1 Products affected

Labeling change

Product Change Notification					PCN Power entry modules with filter		
owner	creation date	release date	released by	change order no	rev	page	D10-008-125
ismaibe	2016-09-07	2016-09-26	blumhe	2011053	A	1 of 2

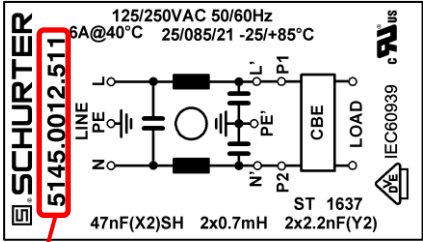
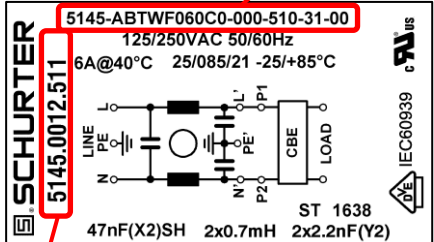
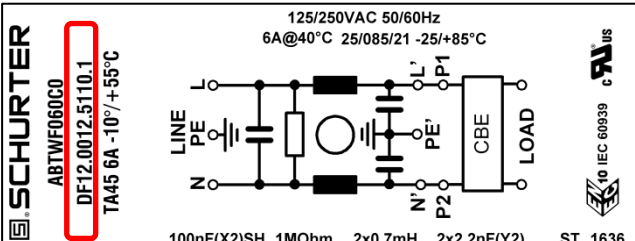
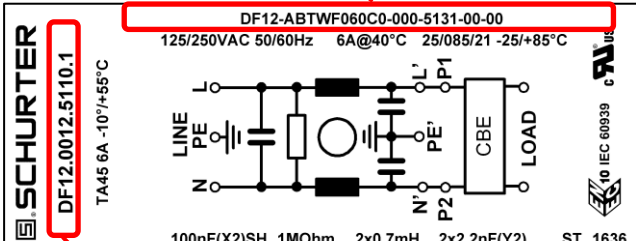
The filter has now a part number and configuration code instead of the order code.

Old label: With order code	New label: With part number and configuration code
<p>Type 5145</p>  <p>Order code</p> <p>Label: 0960.0472 (38x22mm)</p>	<p>Configuration code</p>  <p>Part number</p> <p>Label: 0960.0472 (38x22mm)</p>
<p>Type DF12</p>  <p>Order code</p> <p>Label: 0960.0666 (57x23mm)</p>	<p>Configuration code</p>  <p>Part number</p> <p>Label: 0960.0666 (57x23mm)</p>

For existing products, the order code will be replaced with exactly the same number by the part number. For new products the part number will have a new format e.g. 3-XXX-XXX.

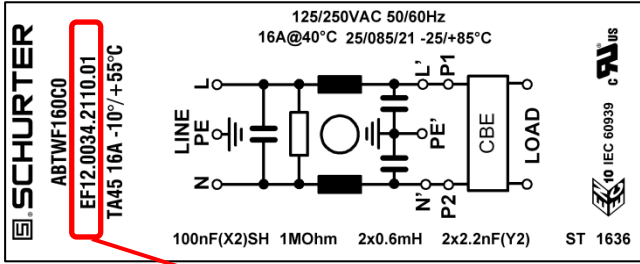
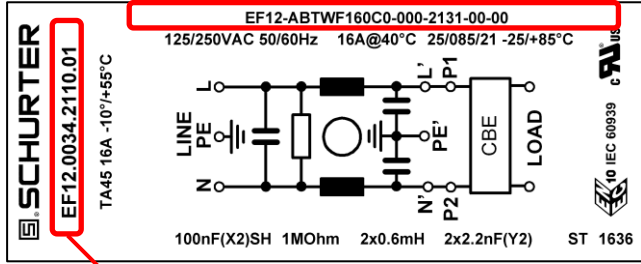
Old label: With order code	New label: With part number and configuration code
<p>Type EF12</p>  <p style="text-align: center;">Order code</p> <p style="text-align: center;">Label: 0960.0666 (57x23mm)</p>	<p style="text-align: center;">Configuration code</p>  <p style="text-align: center;">Part number</p> <p style="text-align: center;">Label: 0960.0666 (57x23mm)</p>
